**Addendum No. 001**

**Subject: 2020 Classroom Modernizations**  
**SDP Contract Numbers: B-022 C of 19/20 & B-024 C of 19/20**

**Location: Fox Chase School**  
**500 Rhawn St, Philadelphia PA 19111**

1 PLUMBING GROUND FLOOR DEMOLITION PLAN  
MPD1.1 1/8" = 1'-0"  
0 4' 8' 16'

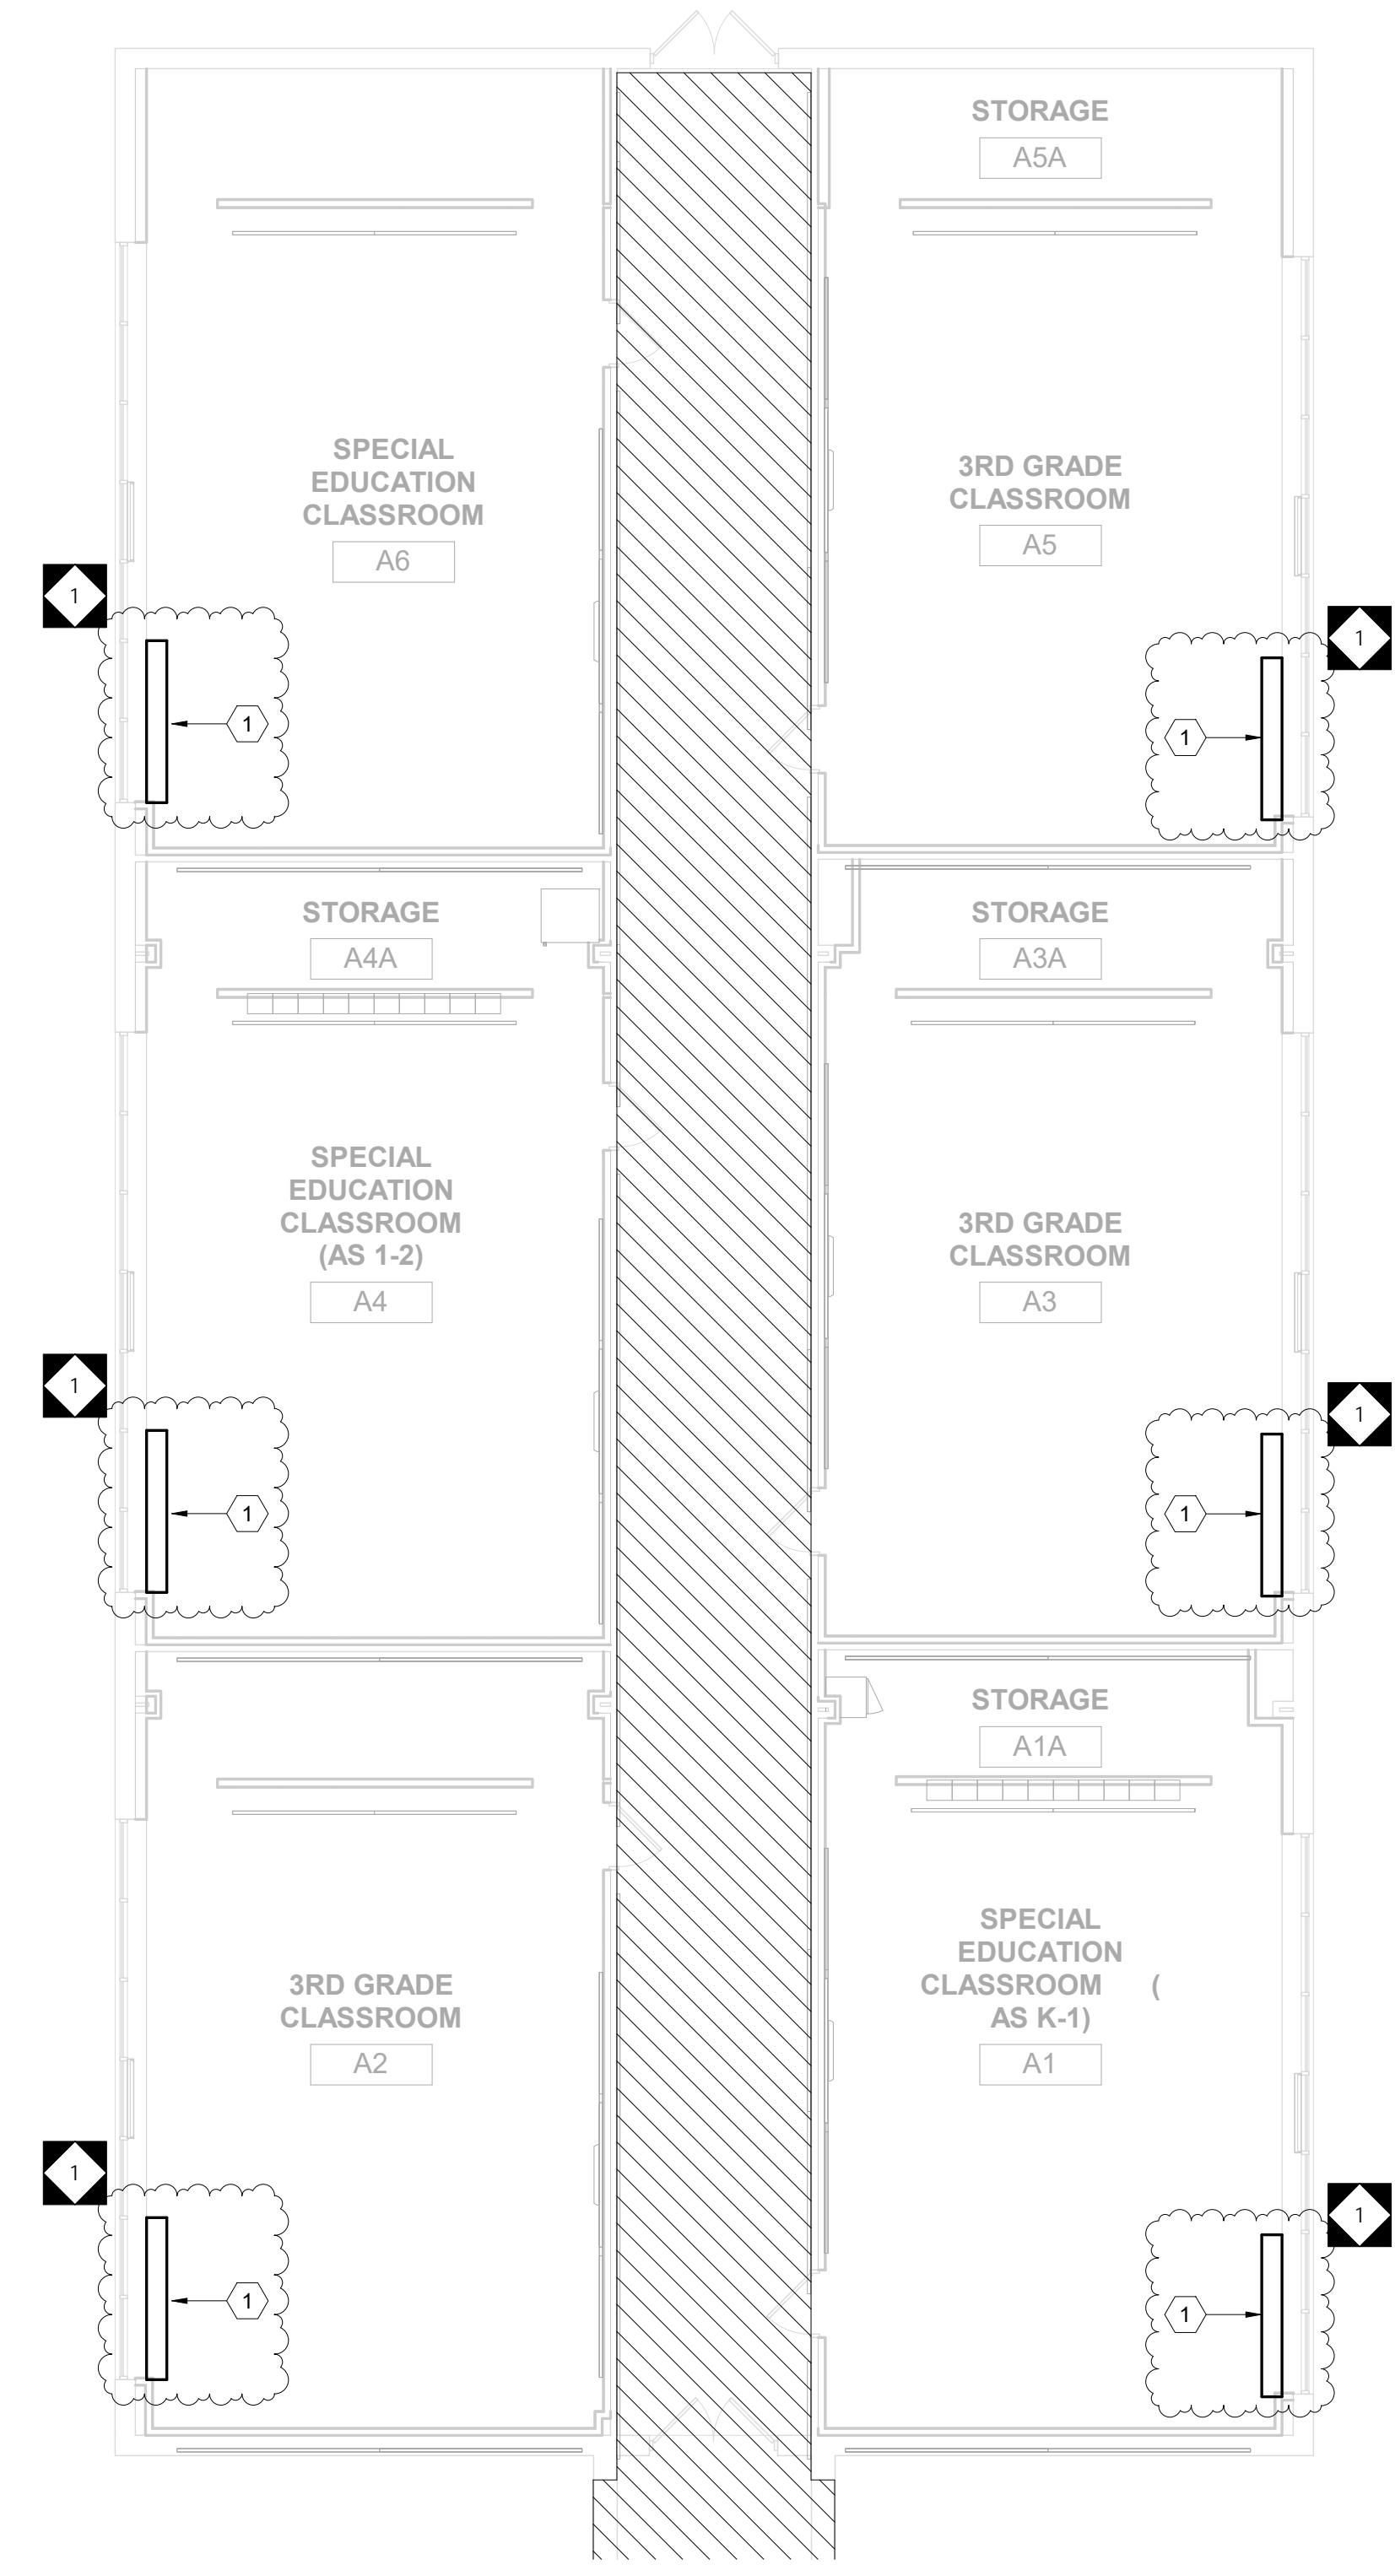
1. REVISE sheet number.
2. REVISE Demolition Key Note 1 to read "REMOVE EXISTING CLASSROOM UNIT VENTILATOR TO ALLOW THE REMOVAL OF THE PLASTER WALL."
3. ADD unit ventilator positions as indicated on the drawings.

1. REMOVE EXISTING CLASSROOM UNIT VENTILATOR TO ALLOW THE REMOVAL OF THE PLASTER WALL.

1 ELECTRICAL GROUND FLOOR DEMOLITION PLAN - AREA C-D  
ED1.1 1/8" = 1'-0"

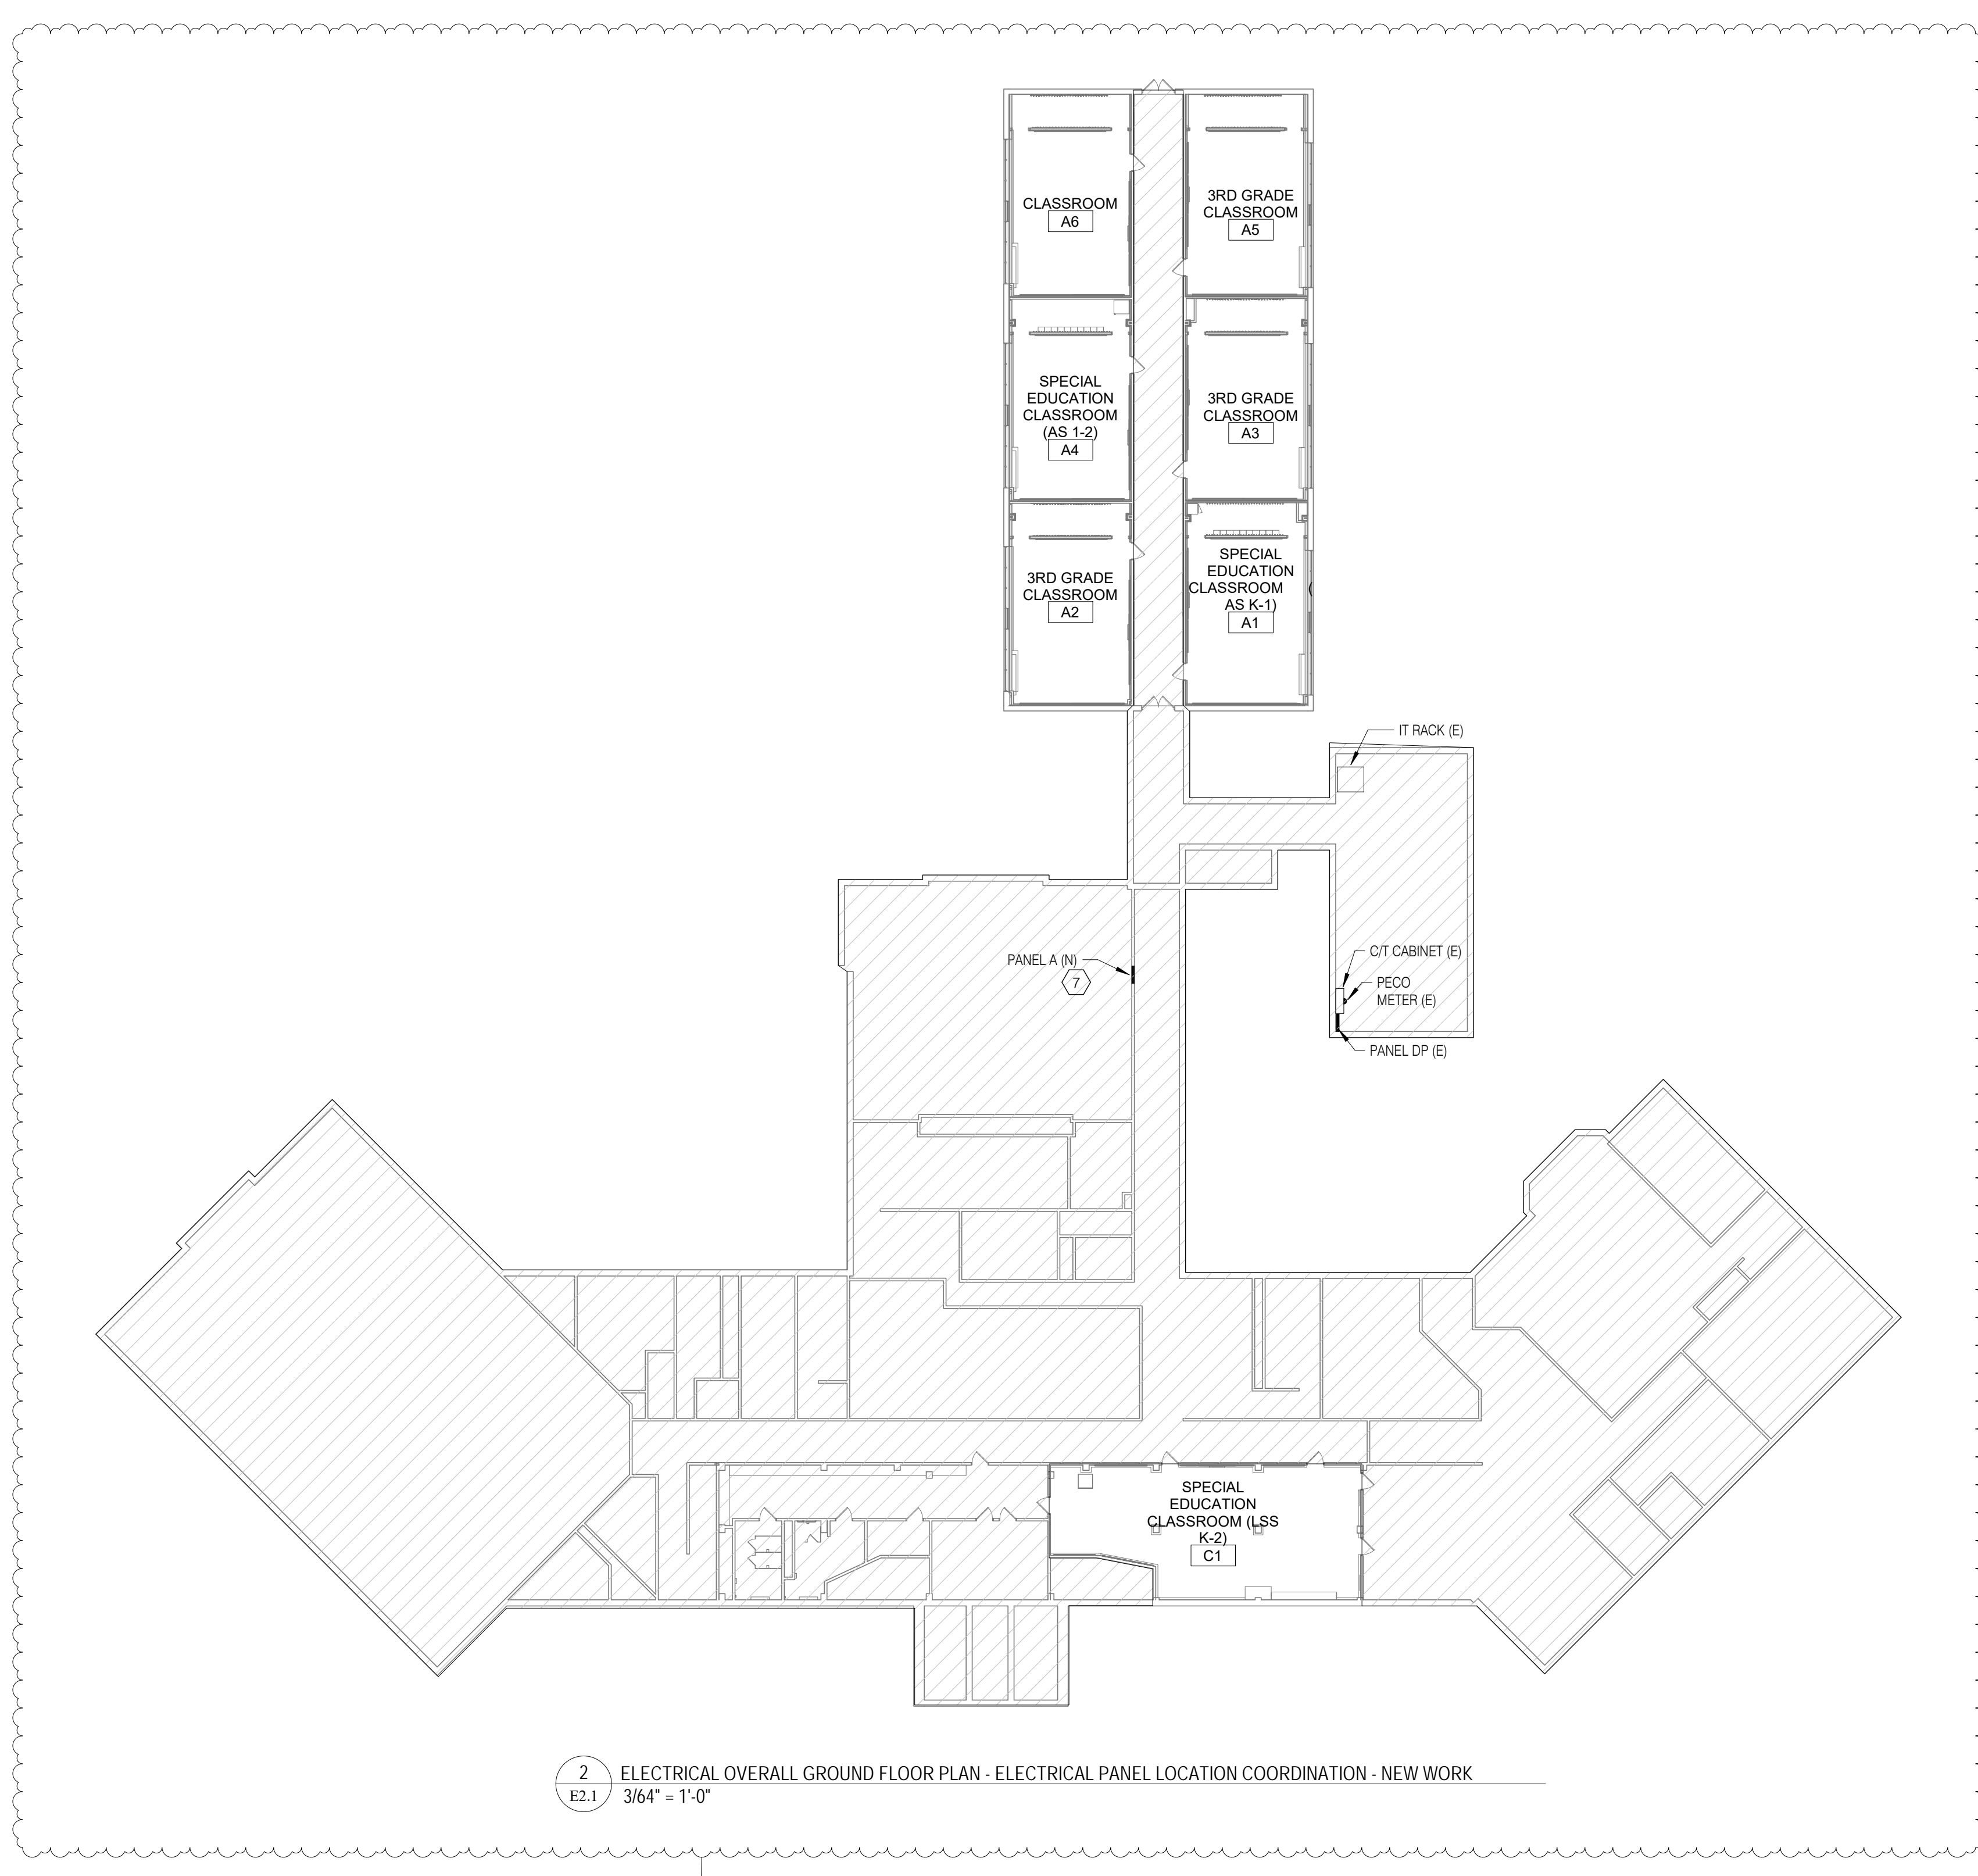
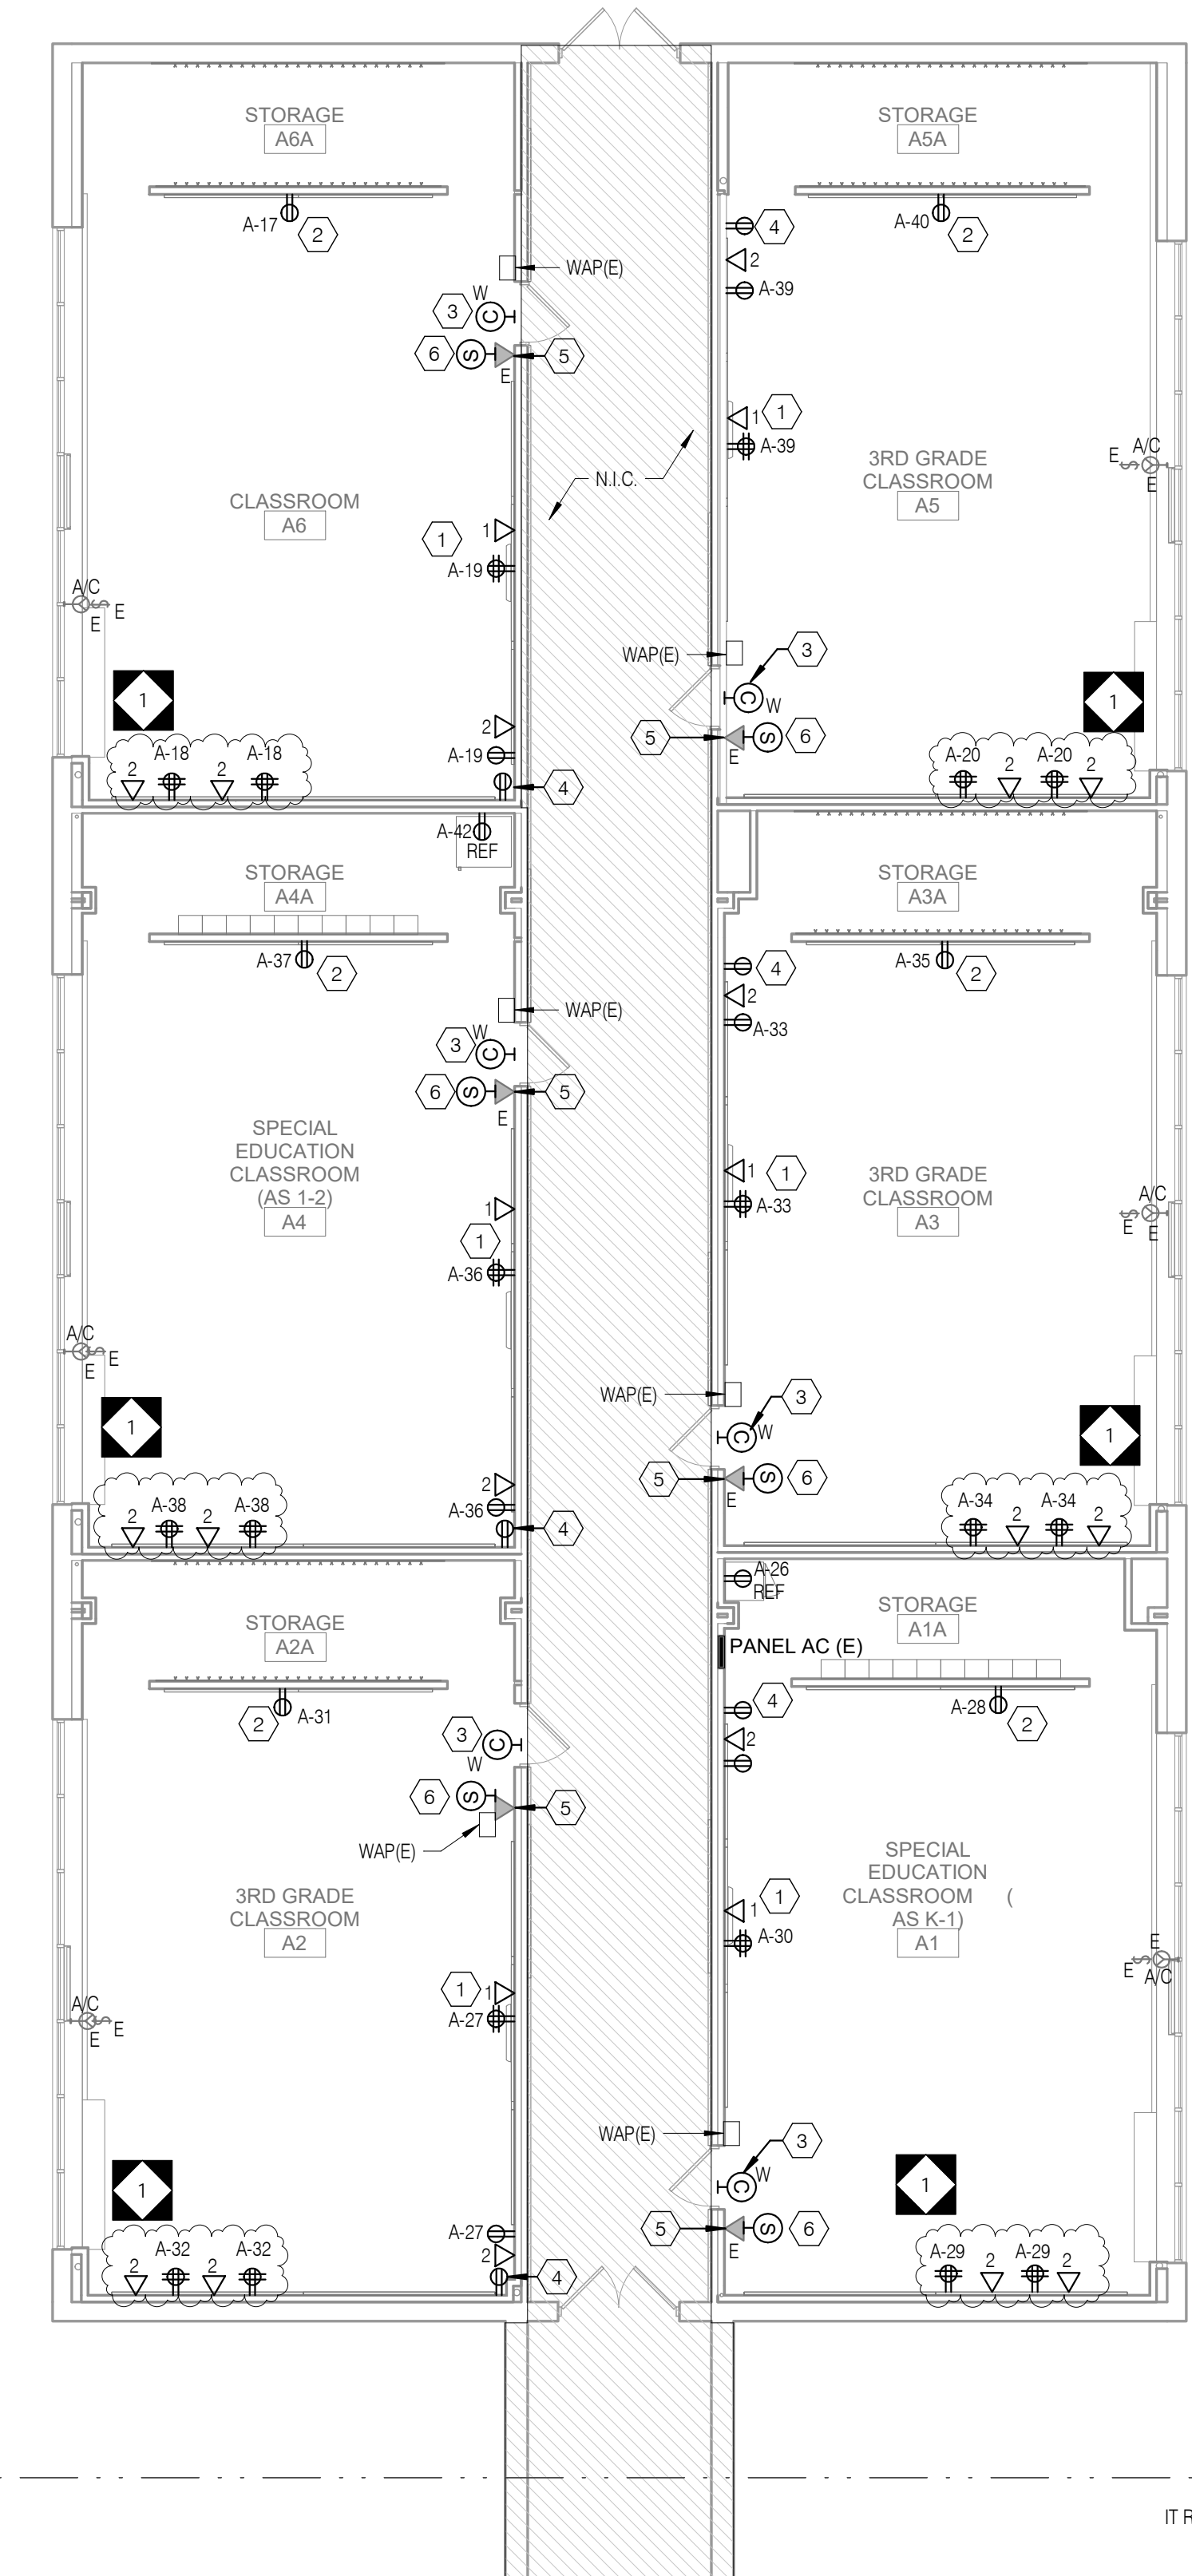
1. REVISE view name for 1/ED1.1 to read "ELECTRICAL GROUND FLOOR DEMOLITION PLAN – AREA C-D."
2. ADD 2/ED1.1 ELECTRICAL OVERALL GROUND FLOOR PLAN – ELECTRICAL PANEL LOCATION COORDINATION – DEMOLITION, as indicated on the drawings.
3. CLARIFY general note in larger font to read "ELECTRICAL CONTRACTOR TO PROVIDE ALLOWANCE FOR REMOVAL OF 10'-0" OF SURFACE MOUNTED RACEWAY/ CONDUIT AND CONDUCTORS IN EACH CLASSROOM."
4. ADD keyed sheet note #12 as indicated on the drawings.

ELECTRICAL CONTRACTOR TO PROVIDE ALLOWANCE FOR REMOVAL OF 10'-0" OF SURFACE MOUNTED RACEWAY/ CONDUIT AND CONDUCTORS IN EACH CLASSROOM.
